System Impact Assessment Report For Niagara-Nanticoke Area Cluster

273 MW New Generation at Thorold by Northland Power
CAA ID Number 2000-003

**990 MW Interconnection Across Lake Erie by TransÉnergie US and
HydroOne Inc.**
CAA ID Number 2000-017

Final Report

FIGURE 7. Exciter and Stabilizer Models for Thorold G1 & G2

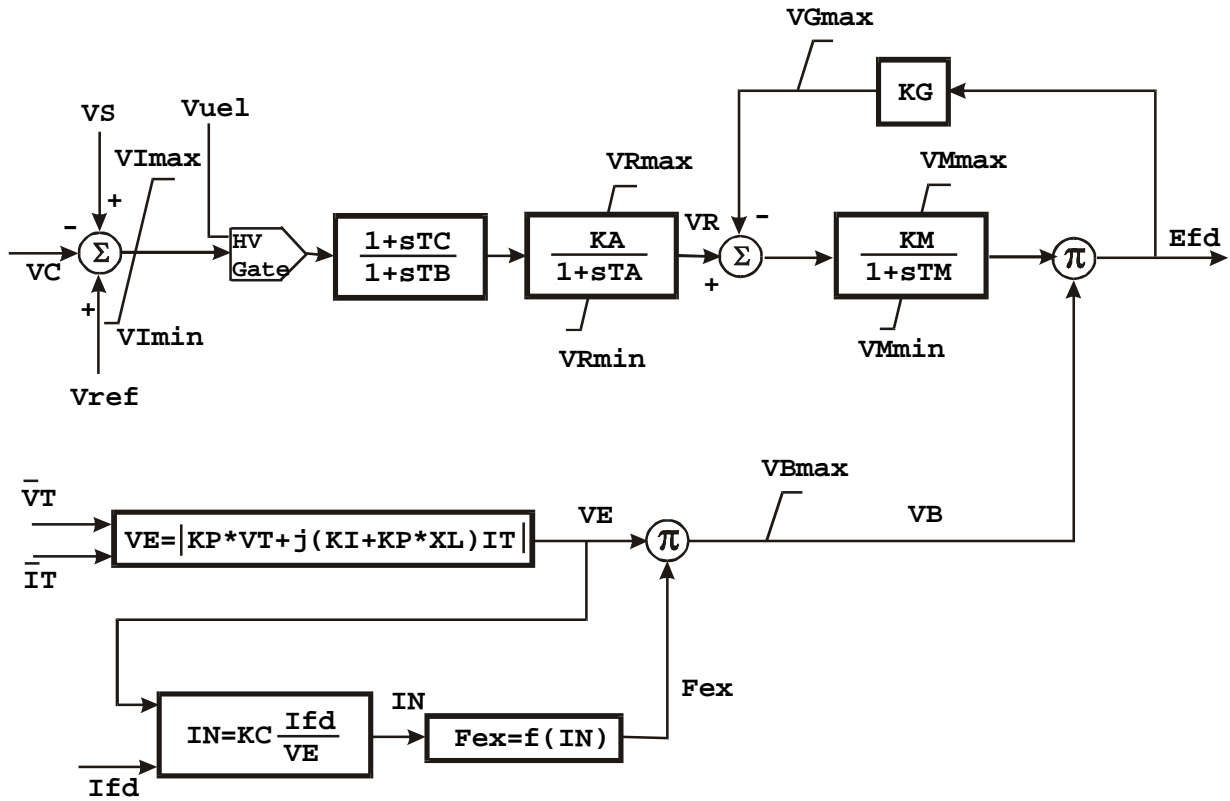
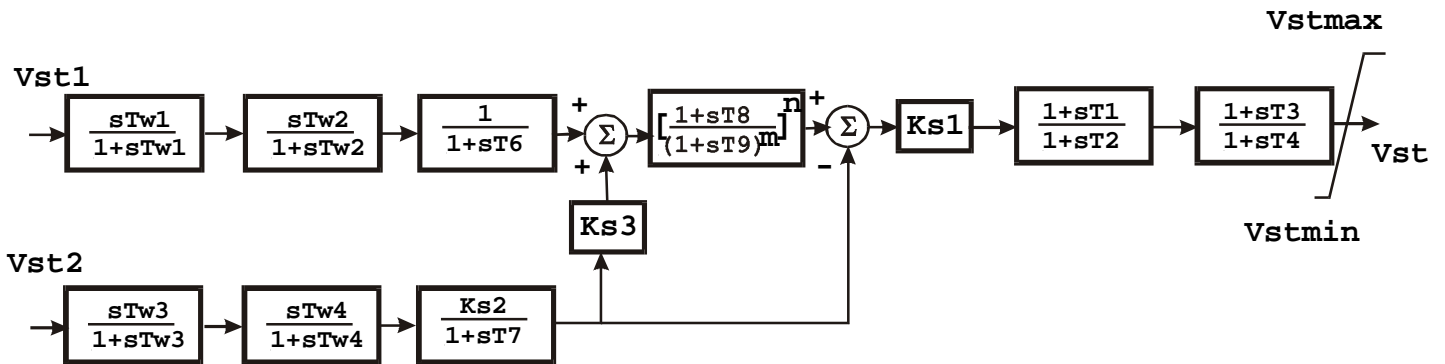
The generator exciter model and data provided by Northland Power Inc. showed that the excitation system has a ceiling voltage of 428 V. The value of the exciter ceiling voltage is below the requirement of the *Market Rules* of 2.0 pu. It is therefore required that the excitation system ceiling voltage be raised.

- The exciter response time is adequate and sufficient damping is provided,
- It is required to raise the exciter ceiling voltage from 427 V to 507 V,
- The stabilizer model and parameters are adequate, but it is required that an adjustable settings range be provided, thus allowing for optimum settings during commissioning,
- The governor model meets the *Market Rules* requirements.

- (A) To stay with the generator design submitted with their application and provide an exciter with a ceiling voltage of 507 V, or
- (B) Change the generator design to meet exactly the *Market Rules* requirements for reactive capability and provide an exciter with a ceiling voltage of 457 V.

Figure 8. Thorold G1&G3 Machine Response to Loss of Double 230 kV Q26A and Q28A

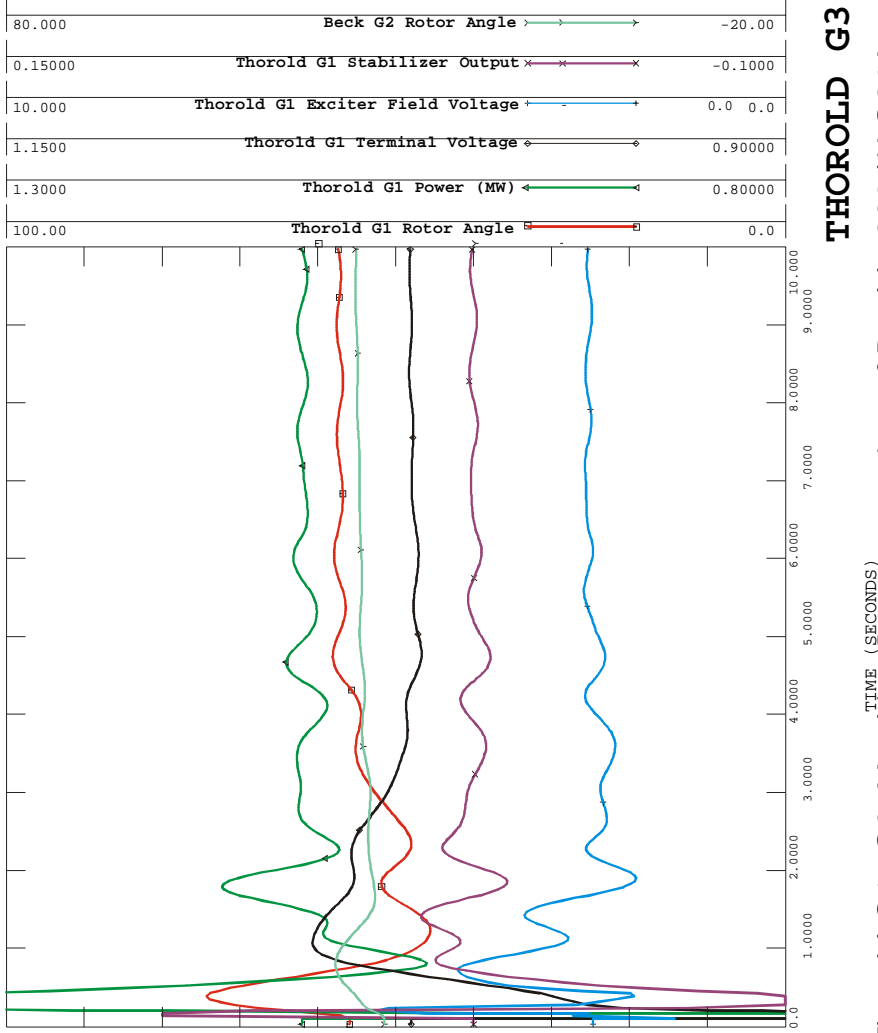
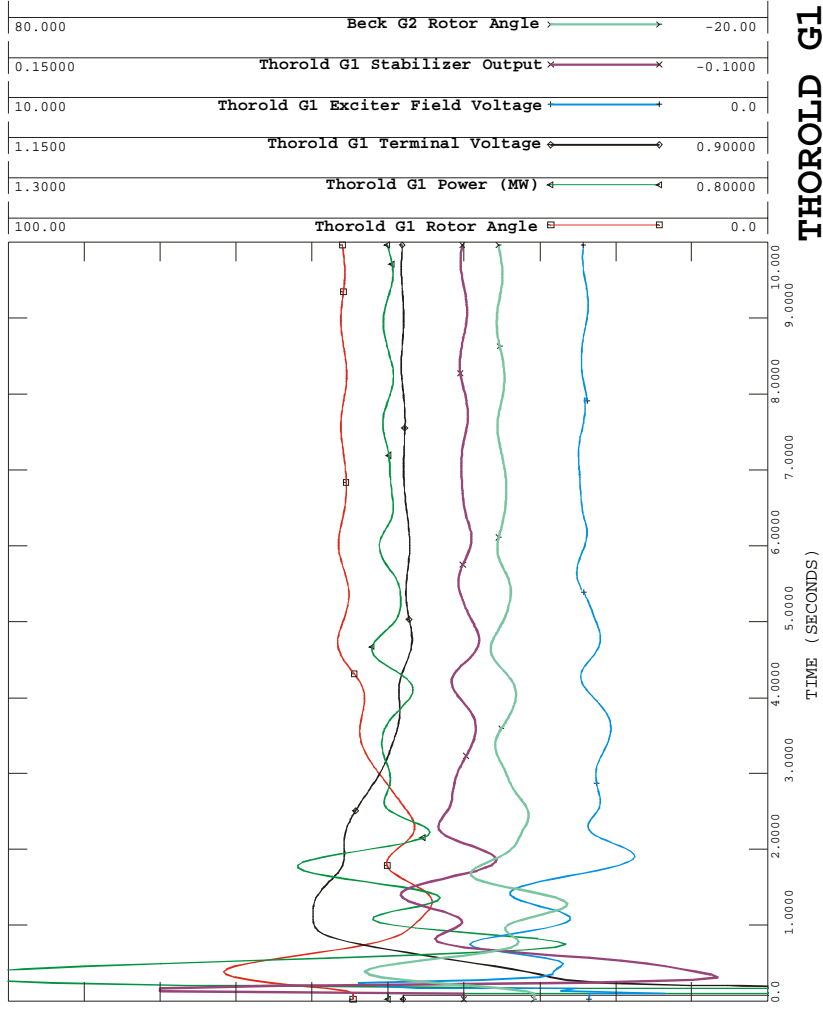
With regard to the exciter response time, the results of transient stability analysis for the Thorold generating unit G1 are shown in Figure 8 attached. These results indicate that the exciter and stabilizer proposed by the connection applicant for installation at Thorold GS have adequate response and provide adequate damping of system oscillations.

FIGURE 9. THOROLD G1&G3 EXCITER RESPONSE

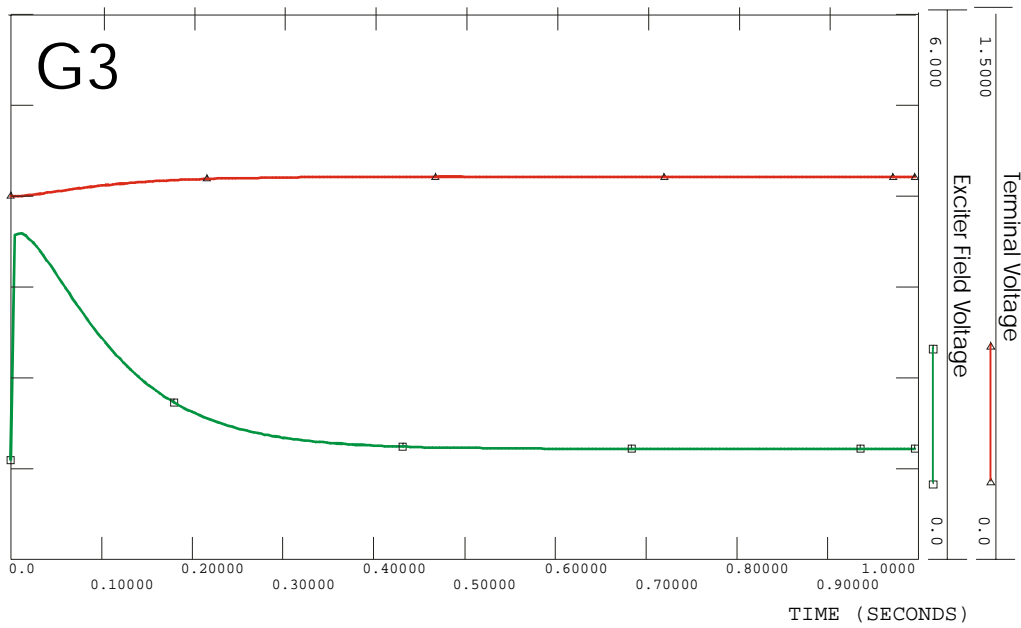
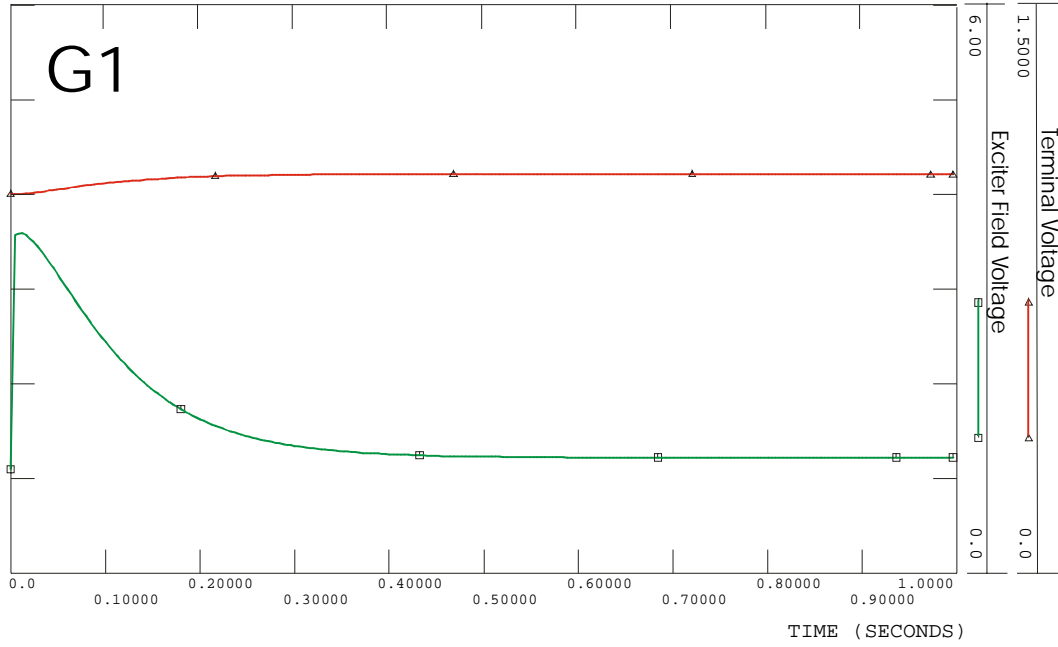
The exciter response time curves for G1 and G3 are shown in Figure 9.
